908 Ocean Street Mixed-Use Development Final Environmental Impact Report

February 2025

SCH #: 2024050531

— — — Proposed Pedestrian Boulevard

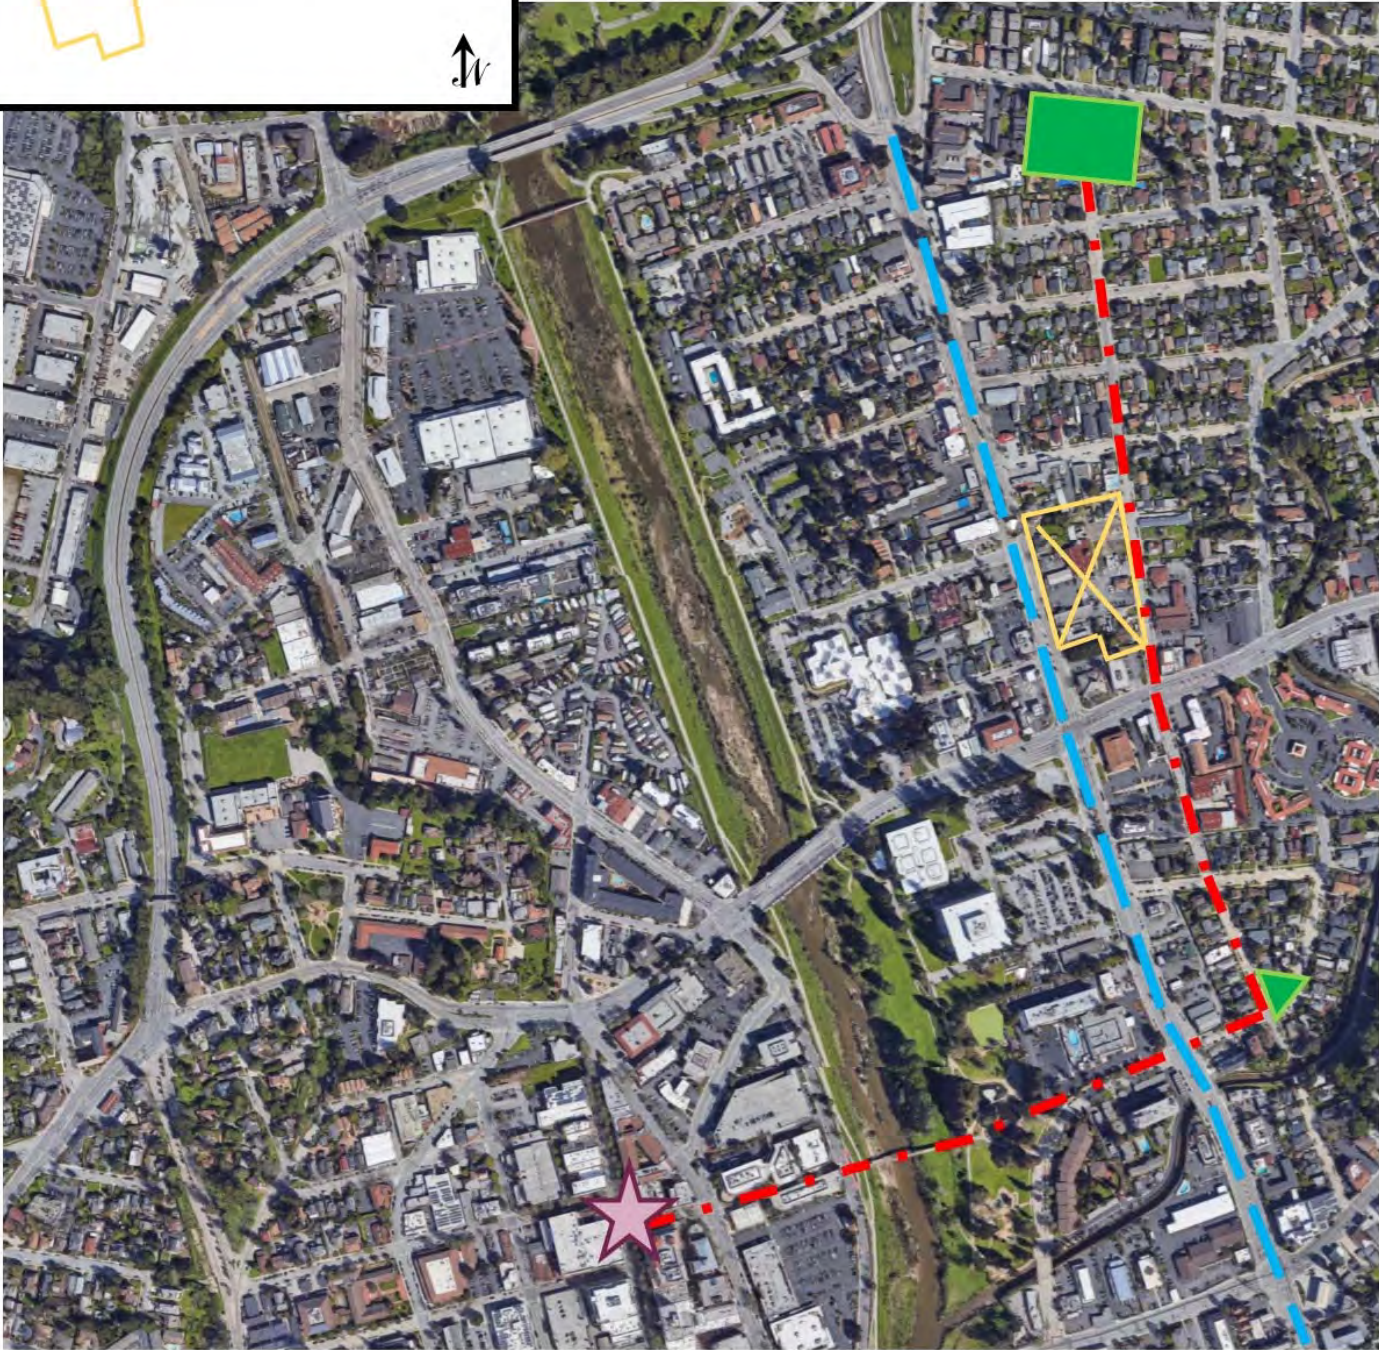
- (1) Provide the "first step" in creating a pedestrian boulevard that begins at Grant Park, follows May Street south across Water Street to Central Park, and turns west on Dakota Avenue to eventually lead to downtown's Pacific Avenue. I would suggest looking to Santa Cruz's Walnut Avenue between Ricon Street and Cedar Street as urban design precedence.

- This "first step" in creating a pedestrian boulevard is selecting an appropriate street tree species that can visually and emotionally connect from your project both north and south. I ask you coordinate with Public Works, Parks & Recreation Department, Planning & Community Development, and our membership to stitch an appropriate urban tree canopy into the fabric on May Street.

I have attached an urban-scale plan schematic that outlines my proposed pedestrian boulevard. If you have any questions, comments, or responses regarding my comments, please do not hesitate to contact me at your convenience.
